Site Plan Review Committee (SPRC)
Staff Report for
4420 Fairfax Drive (The Spire)
SPLA25-00021

4420 Fairfax Drive (SPLA25-00021)
(RPC #14-051-019)

SUMMARY: The applicant, Aria Properties, proposes to add the site to another existing Site Plan, SP #331. They propose to demolish the existing office building to construct a 22-story (with penthouse) multifamily building with 302 apartments and approximately 5,000 square feet of ground floor retail equivalent space.

Figure 18-- Close-up of proposed plaza

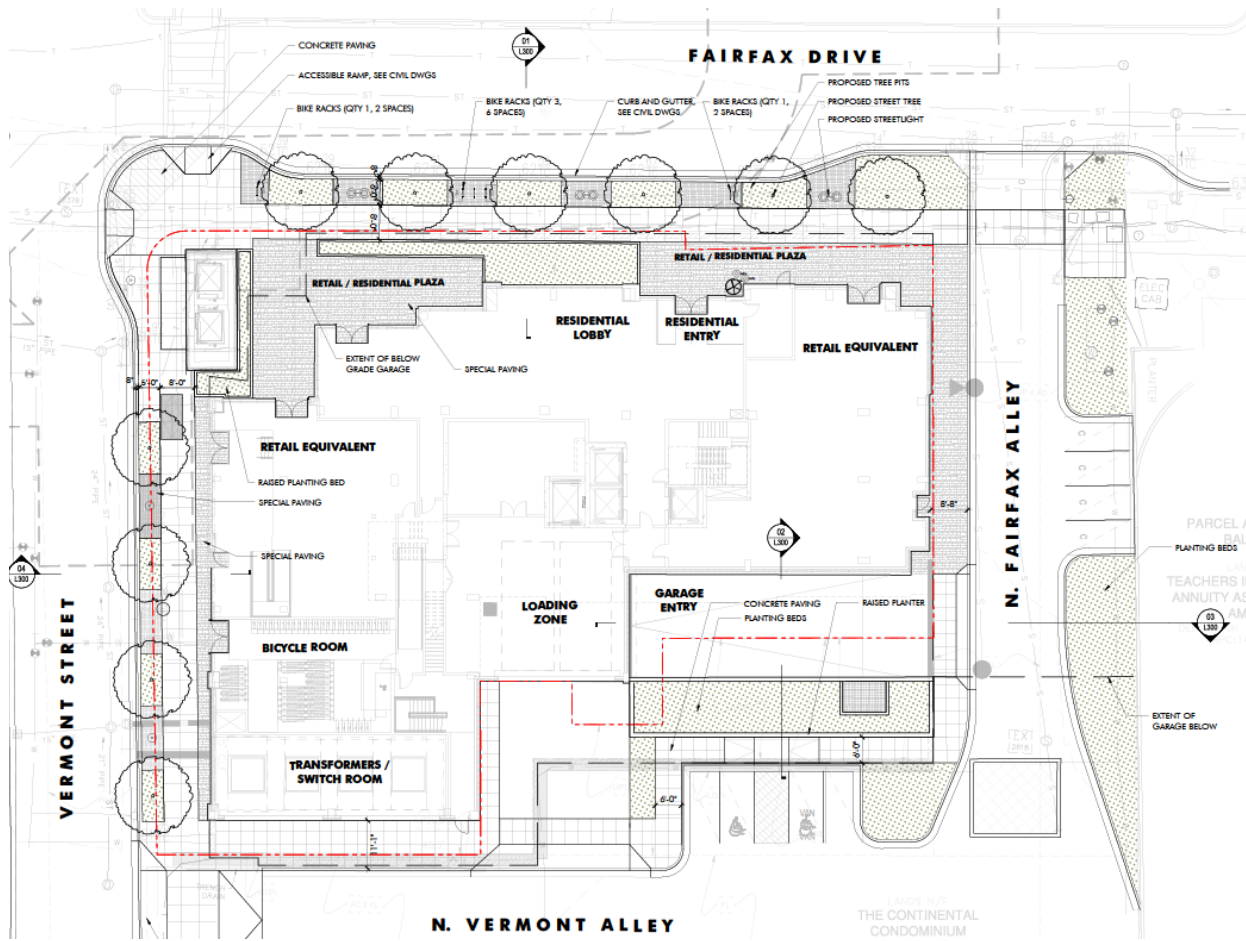
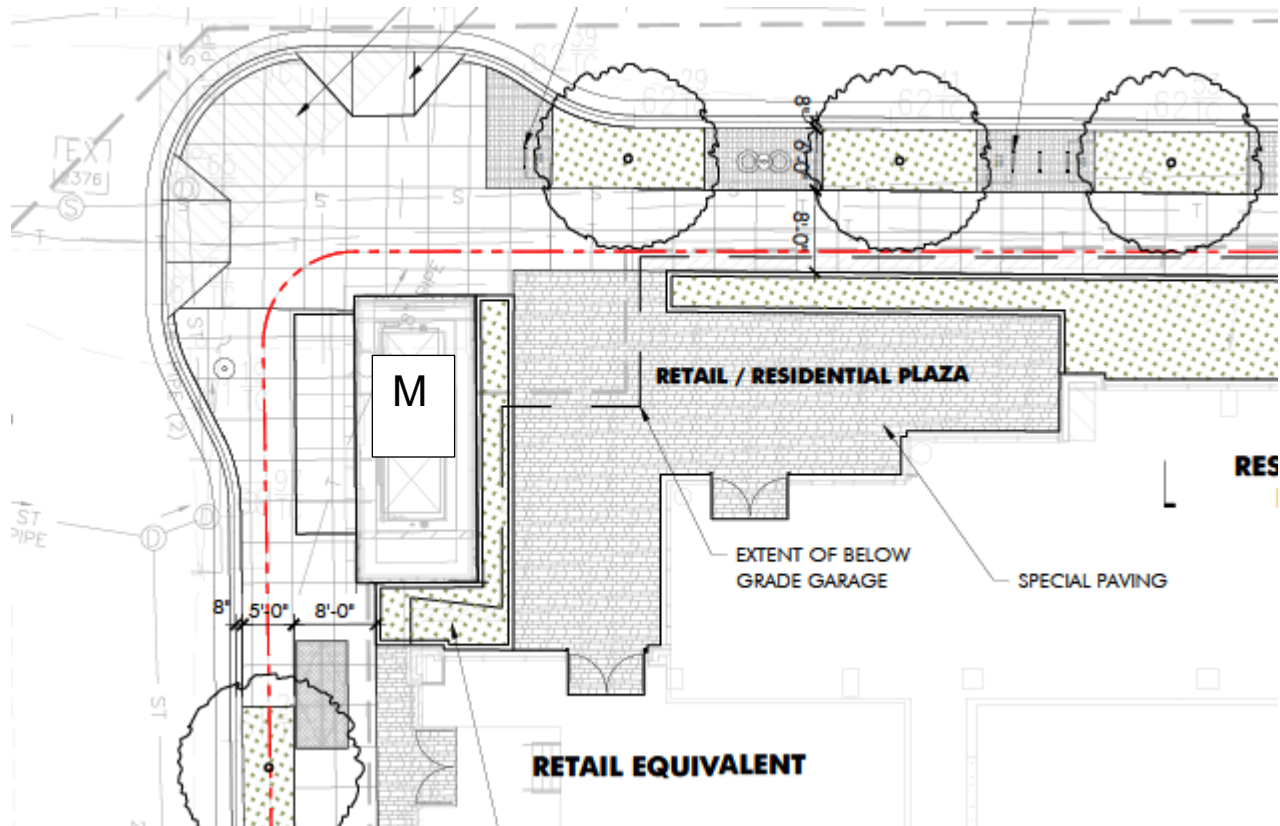
Public Space and Landscaping: The developer proposes a hardscaped public plaza adjacent to the planned Metro Entrance. However, the positioning of the landscaping between the plaza and the Fairfax Drive sidewalk both reduce the clear width of the sidewalk along Fairfax Drive and also creates a barrier from the sidewalk to the public plaza, creating an air of privacy. The Ballston Sector Plan recommends that plazas have “a minimum of one tree per 500 square feet and 150 square feet of grass or groundcover per 1,000 square feet of plaza area.” Staff recommends that the onsite landscaping be rearranged so that it does not obstruct clear paths.

- Landscaping strip on Fairfax Drive interferes with sidewalk width; Clear width of Fairfax Drive sidewalk recommended minimum 16 feet;

- Continue to coordinate with County project for second Ballston Metro entrance;
- Public plaza designs adjacent to Metro entrance; Landscaping encloses proposed public plaza
- Longstanding policy and good urban design practice discouraging surface parking in Metro corridors; Removing surface parking on Vermont Alley would provide opportunity for straighter pedestrian pathway on north side, more green space;
- Above grade transformers, presence and design;
- Bus stop location.

Figure 21. Proposed Fairfax Drive Cross-Section (Facing East)

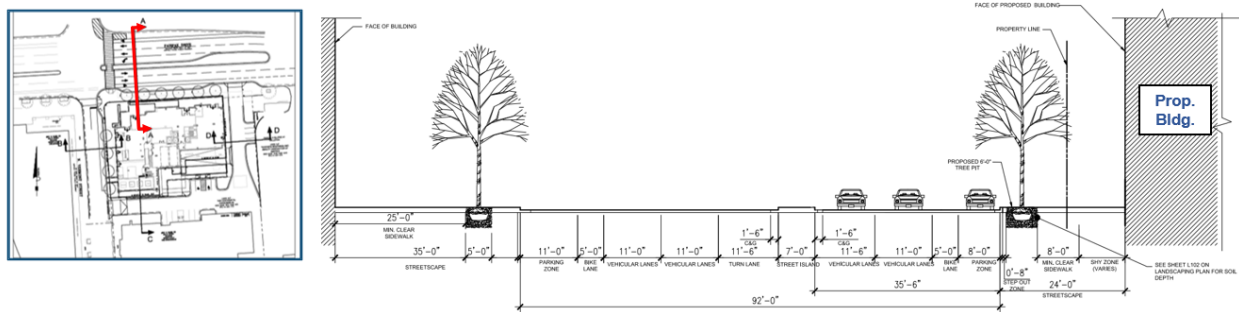
The applicant proposes a 24-foot-wide streetscape consisting of a 0.67-foot-wide step out zone, a 6-foot-wide-tree pit, an 8-foot-wide clear sidewalk, and a minimum of a 9.3-foot-wide shy zone. The proposed tree pit will be located adjacent to the curb. Double globed streetlights are proposed to be in line with the tree pits. Bike parking is proposed within the furniture zone.
